Technical Note 3: Response to WSP Comments

Site: 19 Farncombe Road, Worthing, West Sussex
Prepared by: Phil Allen MCIWEM C.WEM
Approved by: Neil Jaques
Date: 18th February 2026

- 1.1 This technical note has been produced by Motion to respond to WSP's comments relating to the drainage strategy on consents AWDM/1522/24 and AWDM/1567/24 at 19 Farncombe Road, Worthing, West Sussex.

Ring Soakaways

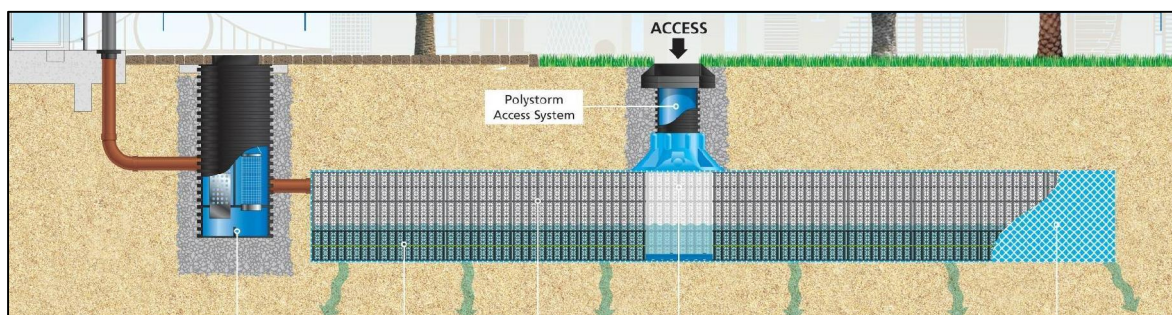
- 3.19 To help WSP with their under our approach, and to explain why Motion will not depart from standard and exclude base infiltration from the geocellular soakaway, we have set out a step-by-step explanation, below, explaining the key differences between ring soakaways and geocellular soakaways and to clearly demonstrate to the LPA (and any reviews by others in the future) why WSP's position on this is unsustainable.

- 3.20 Ring soakaways are basically manhole rings with perforated walls. They are set within a gravel surround and have solid bases (like a manhole). See the below picture of a ring soakaway.

- 3.21 When using (and designing for) ring soakaways, infiltration should only be specified from the sides; as noted above, they usually have solid bases and, because they are usually taller than they are in diameter, the sides are the largest surface area and allow the successful discharge of surface water into the surrounding gravel. This fact is supported in MicroDrainage and the design parameters within the hydraulic modelling software allow for this exact approach.
- 3.22 So, to confirm, because ring soakaways often have solid bases, infiltration is rarely included from this part of the structure, but it is not detrimental to the function of ring soakaways because the sides of the structure form most of the functional surface area.

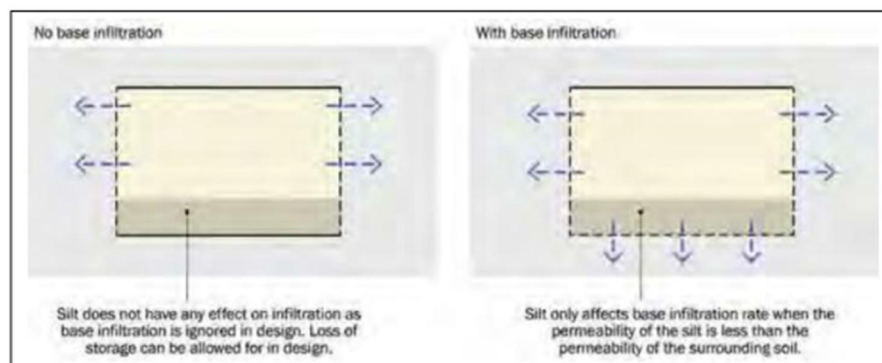
- 3.27 The only time when the base of geocellular soakaways should have infiltration from the base of the structure reduced is when very good natural infiltration rates exist, and it is expected that some siltation will occur over time on the base of the tank, and this will result in slower infiltration rates from the base of the tank than the sides. We detailed this in our previous Technical Note to WSP (TN03) and included guidance taken direct from the design instructions in the CIRIA C753 SuDS Manual. However, as mentioned above, WSP have not acknowledged this in their response. For ease of reference, it is below:

"Section 25.4 of the CIRIA SuDS Manual Guidance outlines the impacts of siltation on the performance of infiltration systems, comparing scenarios with and without base infiltration. Figure 25.6 of the CIRIA SuDS Manual states that 'Silt only affects the base infiltration rate when the permeability of the silt is less than the permeability of the surrounding soil'. It further notes that 'If the surrounding soil has similar permeability to the silt then there will be little effect'. Silt typically has a permeability of around 1×10^{-6} m/s.

- 3.28 The soakaway that has been designed for 19 Farncombe Road has an infiltration rate of 1.17×10^{-6} m/s, which is slower than that of silt. As a result, the impact of siltation on systems performance is expected to be negligible."

Drawing:
2409049-0500

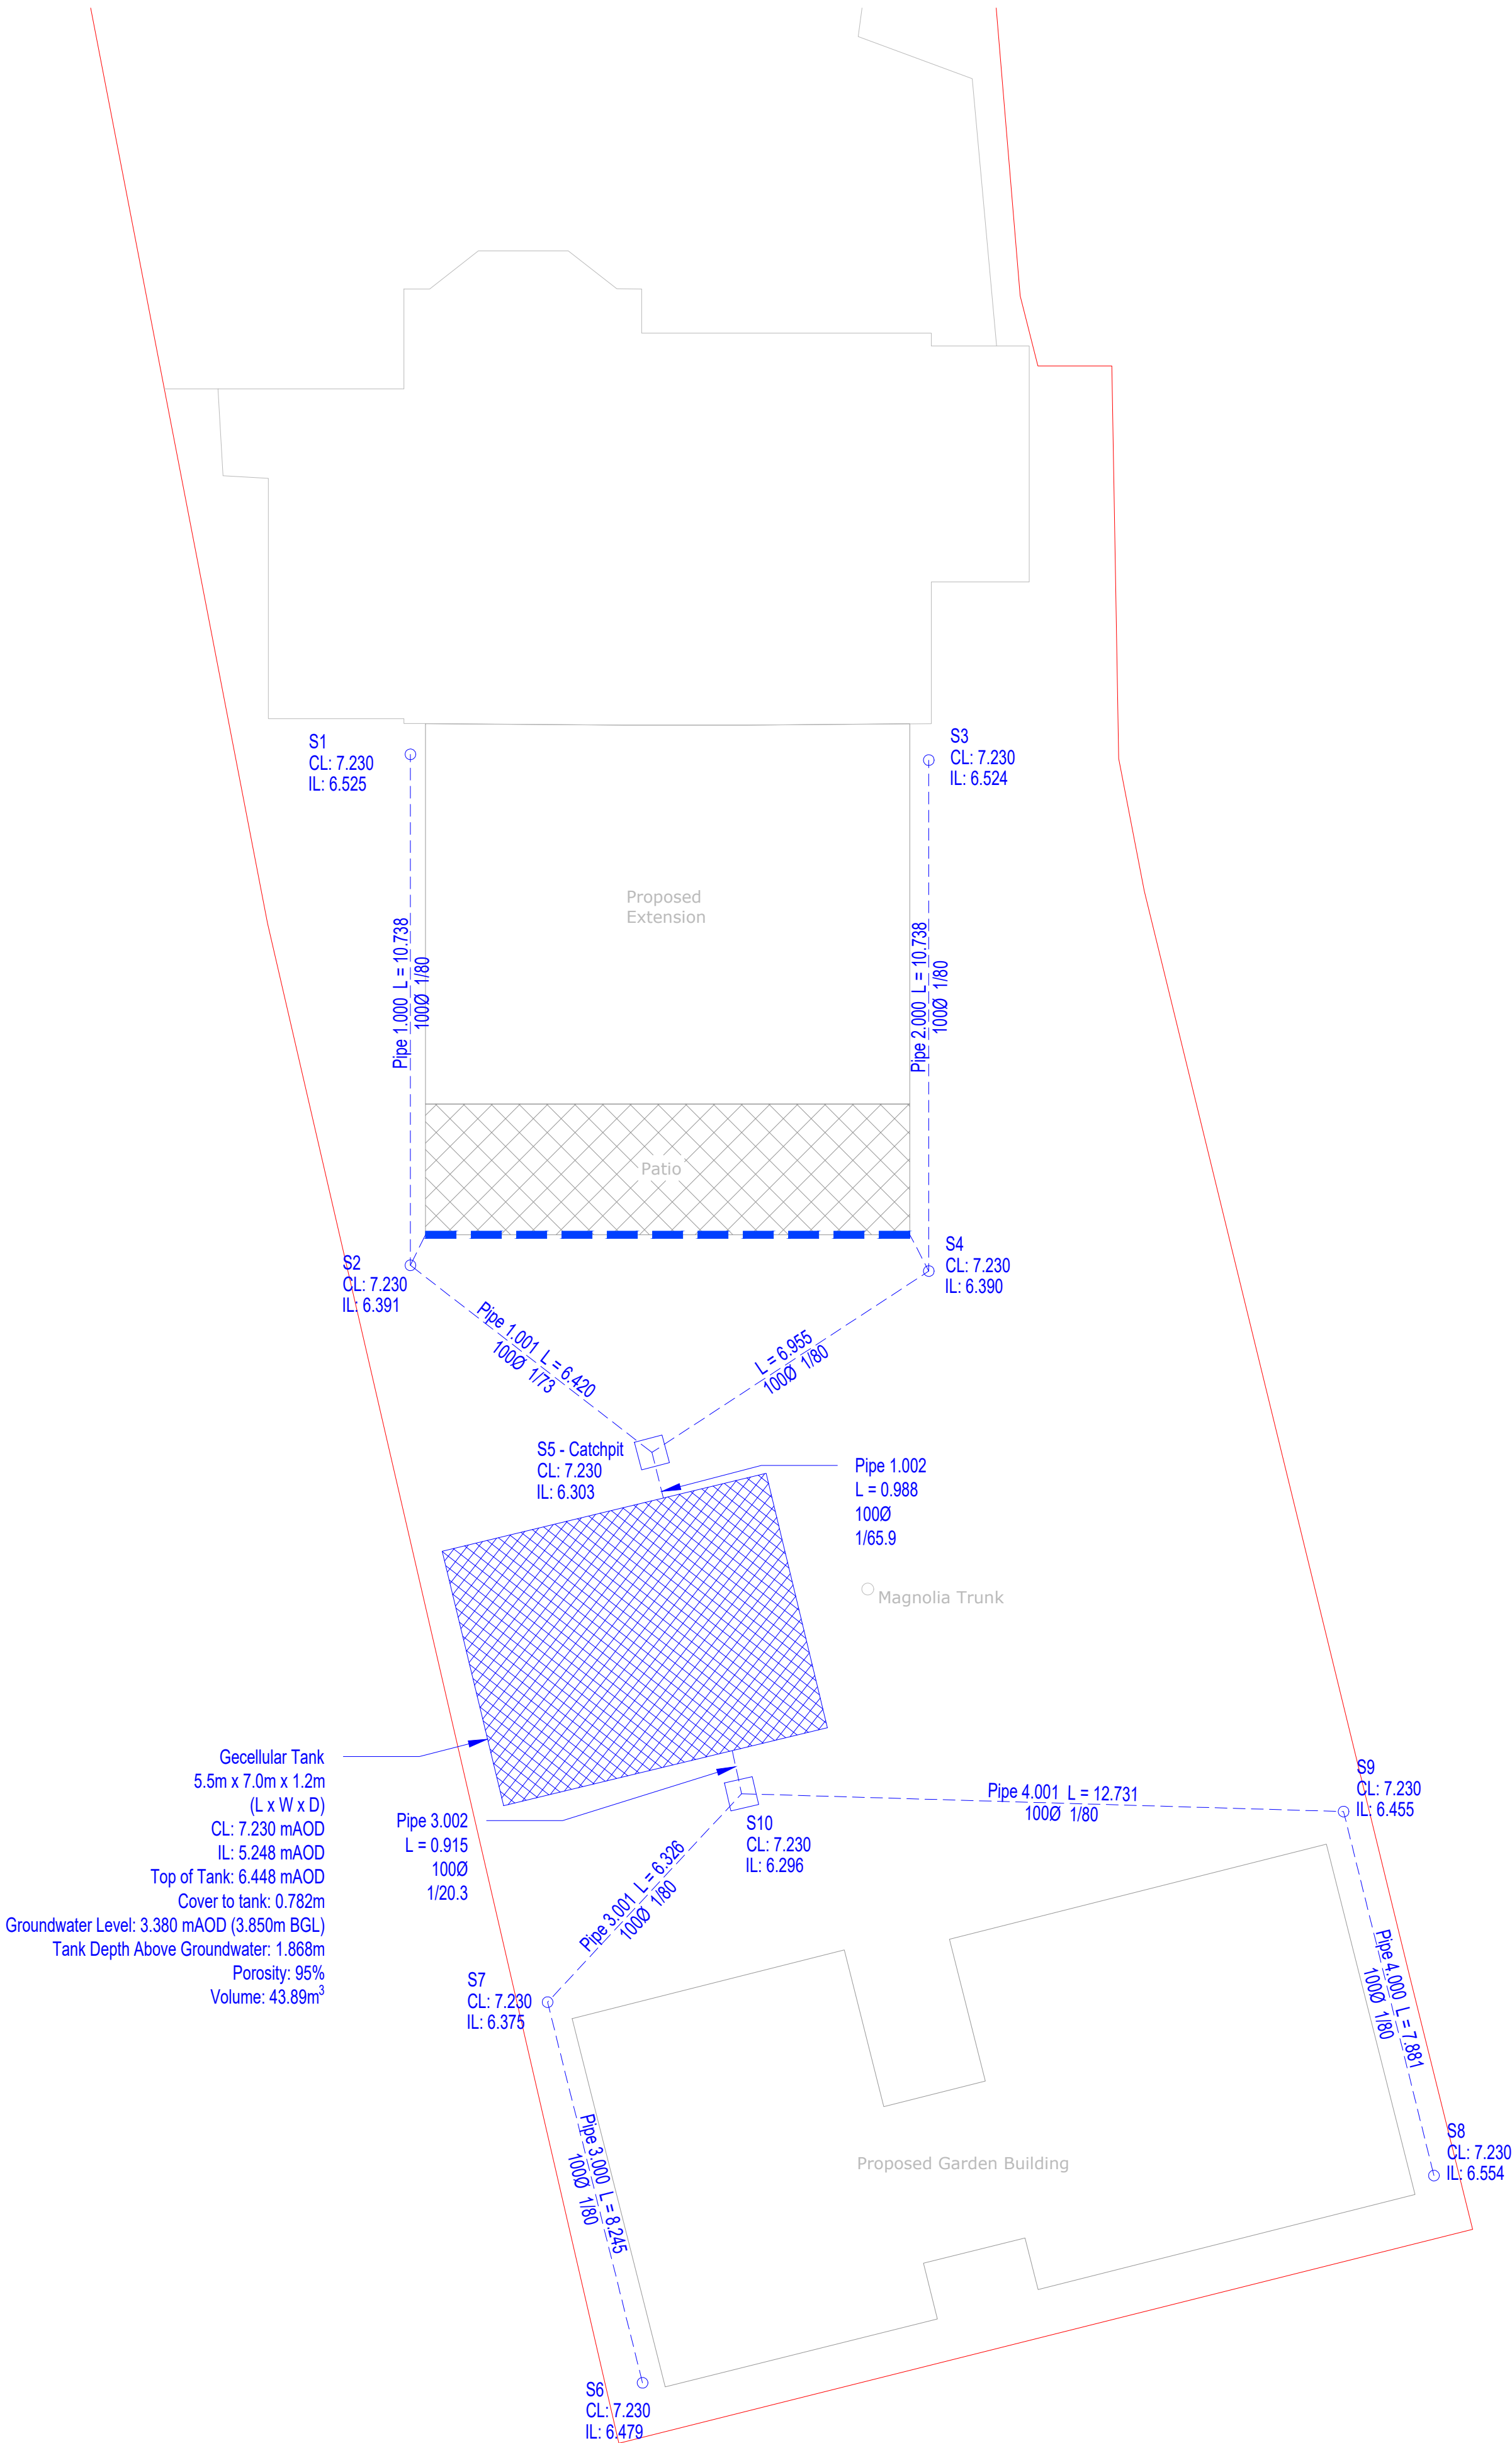
- 1.2 WSP do not consider the drainage conditions to be discharged, and have stated that they still have concerns regarding the following:
- § *Half drain time has been shown to be well above 24 hours. If a half drain time of 24 hours cannot be achieved, then we would expect to see consecutive storm calculations showing that the system can cope with a subsequent 1 in 10-year event without flooding occurring at the site.*

- § *We recognise the use of catch pits and pretreatment measures; however, as a standard across all planning applications, we still require calculations to only use side infiltration.*

- 3.3 In order to successfully demonstrate the above, the dimensions of the geocellular soakaway structure were increased further to 7.0m x 5.5m x 1.2m (L x W x D). This, inclusive of the geocellular soakaway's 95% porosity, provides a total available attenuation volume of 43.890m³.

- 3.14 The detailed drainage layout has been updated to represent the changed soakaway dimensions, and this can be seen in [Appendix D](#).
- 3.15 With the provision of the information above and in the appendices, WSP can discharge the condition.
